World Forum for Harmonization of Vehicle Regulations**Working Party on Passive Safety****Seventieth session**

UN Regulation No. 12 (Steering mechanism)**Proposal for the 05 series of amendments to UN
Regulation No. 12 (Steering mechanism)****Submitted by the expert from the Netherlands ***

The text reproduced below was prepared by the expert from the Netherlands, aiming to update the requirements for post-crash electrical safety in the event of frontal impact collision. It is based on informal document GRSP-69-08 submitted by the expert from the Netherlands and informal document GRSP-69-04 submitted by the expert from CLEPA at the sixty-ninth session of the Working Party on Passive Safety (GRSP). The modifications to the current text of the UN Regulation are marked in bold for new or strikethrough for deleted characters.

Figure 4
Example of test method using DC power supply

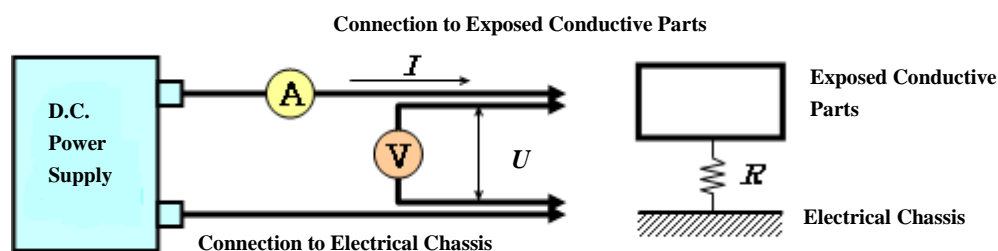
The resistance tester is connected to the measuring points (typically, electrical chassis and electro conductive enclosure/electrical protection barrier) and the resistance is measured using a resistance tester that meets the specification as follows:

- (i) Resistance tester: Measurement current at least 0.2 A;
 - (ii) Resolution: 0.01 Ω or less;
 - (iii) The resistance R shall be less than 0.1 Ω .
- (b) Test method using DC power supply, voltmeter and ammeter.

The DC power supply, voltmeter and ammeter are connected to the measuring points (Typically, electrical chassis and electro conductive enclosure/electrical protection barrier).

The voltage of the DC power supply is adjusted so that the current flow becomes at least 0.2 A.

The current "I" and the voltage "U" are measured.

The resistance "R" is calculated according to the following formula:

$$R = U / I$$

The resistance R shall be less than 0.1 Ω .

Note: If lead wires are used for voltage and current measurement, each lead wire shall be independently connected to the electrical protection barrier/enclosure/electrical chassis. Terminal can be common for voltage measurement and current measurement.

An example of the test method using DC power supply, voltmeter and ammeter is shown below.

Figure 5
Measurement of U_1'

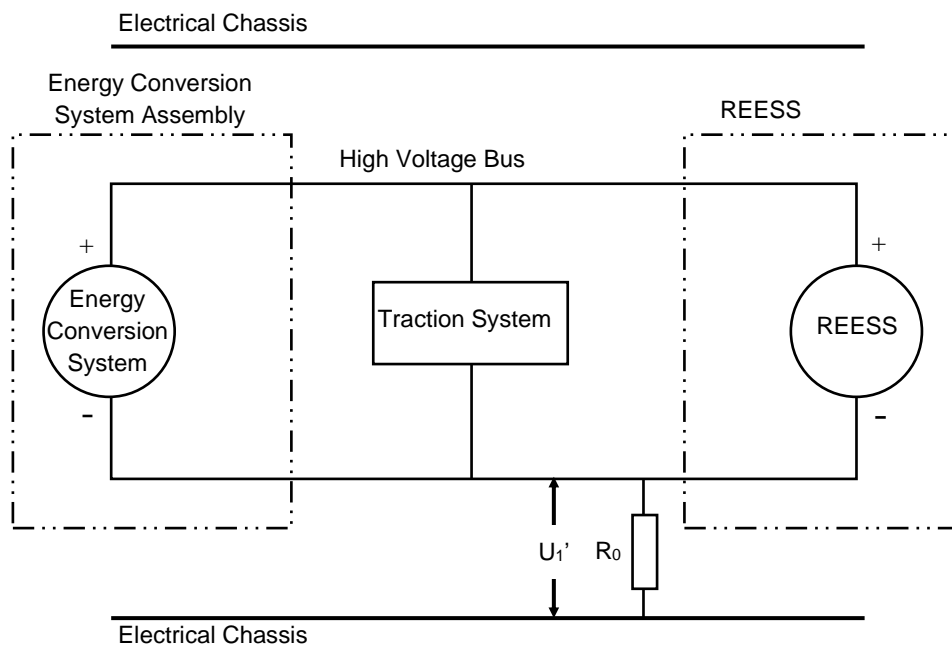
If U_1 is greater than or equal to U_2 , a standard known resistance (R_0) is inserted between the negative side of the high voltage bus and the electrical chassis. With R_0 installed, the voltage (U_1') between the negative side of the high voltage bus and the electrical chassis is measured (see Figure 5).

The electrical isolation (R_i) is calculated according to the following formula:

$$R_i = R_0 \cdot U_b \cdot (1/U_1' - 1/U_1)$$

Figure 6
Measurement of U_2'

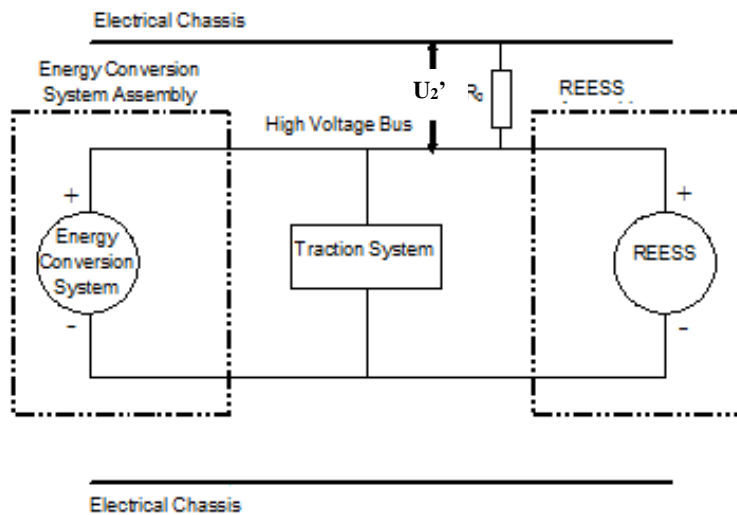
If U_2 is greater than U_1 , insert a standard known resistance (R_0) between the positive side of the high voltage bus and the electrical chassis. With R_0 installed, measure the voltage (U_2') between the positive side of the high voltage bus and the electrical chassis (see Figure 6 below). The electrical isolation (R_i) is calculated according to the following formula:

$$R_i = R_0 \cdot U_b \cdot (1/U_2' - 1/U_2)$$
